**Re: Notification of Change to Landfill Gas Barrier Design  
Interim Action Work Plan Implementation – City of Yakima Landfill Site Roadway Project  
Agreed Order No. DE 15861**

Drawing ES1 (Revised) – Excavation Sections

CITY OF YAKIMA  
 BRAVO COMPANY BLVD. MSW AND WOOD DEBRIS REMOVAL  
 EXCAVATION SECTIONS

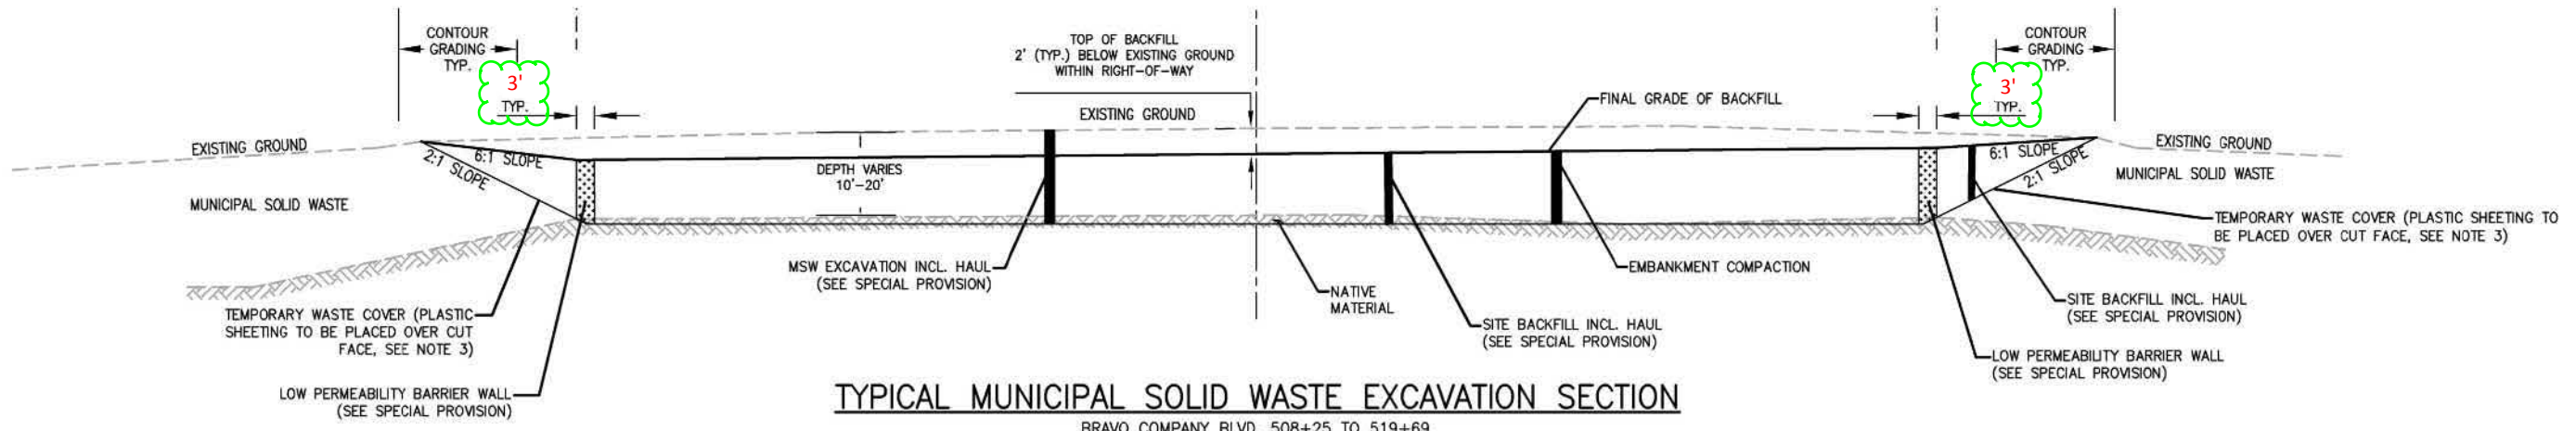
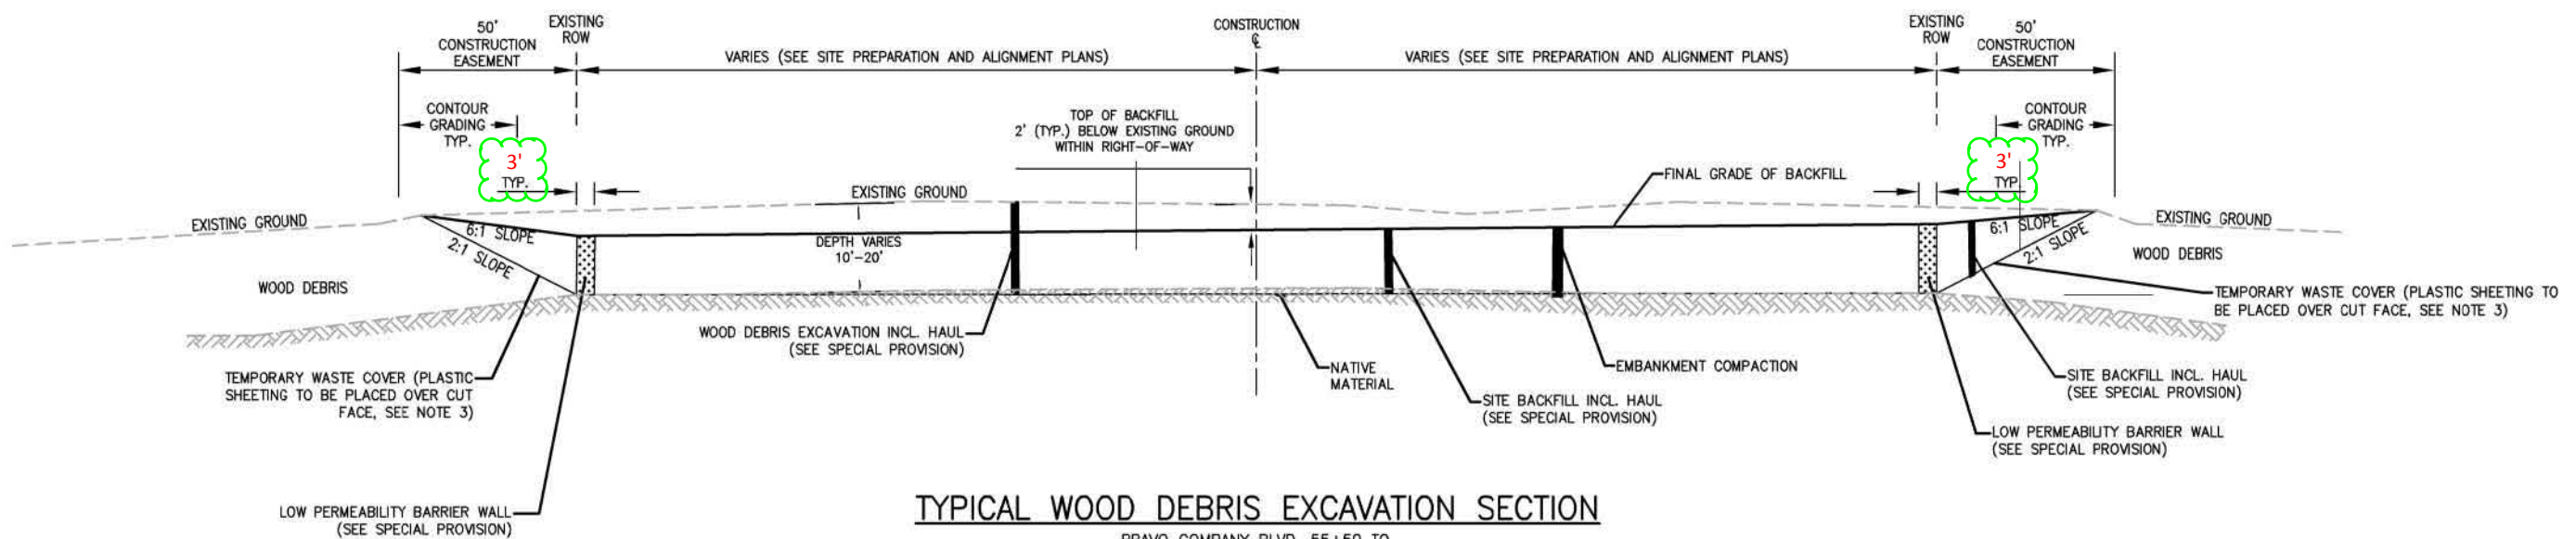
LAI is approving a minor modification to the design criteria for the low-permeability wall, consisting of changing the nominal width of the wall from 4 ft to 3 ft (see attached revised project design Drawing ES1). All other design criteria for the low-permeability wall will remain unchanged. This design change still provides for a design with anticipated performance that is consistent with the objectives of the IAWP.

To minimize the overage during construction of the remainder of the low-permeability wall, the modified nominal wall width of 3 ft has been evaluated and is being approved by LAI based on the following factors:

- Based on the Contractor's construction means and methods for the low-permeability wall, at a nominal width of 3 ft, the actual average width of the wall will be around 4 ft across each 4-ft-deep section (as a result of the same non-vertical trench sidewall issue that is causing the current material overages).

- Contractor's test results for the actual soil being used for construction of the low-permeability wall indicate that a hydraulic conductivity of around  $2 \times 10^{-7}$  can be achieved when the moisture content is between 19 and 29 percent and compaction is at least 90 percent of its maximum in-place dry density of 107 pounds per cubic foot (pcf; or about 96.3 pcf). Based on field quality assurance testing during installation, the Contractor has consistently met these moisture and density criteria. This resulting hydraulic conductivity is nearly an order of magnitude lower than the specified hydraulic conductivity; thereby, resulting in a less permeable and more effective LFG barrier than required to meet the LFG migration mitigation objectives for the low-permeability wall.

NO.	DATE	BY	APPR.	REVISIONS
1	5/12/21	PMR		Minor Revision
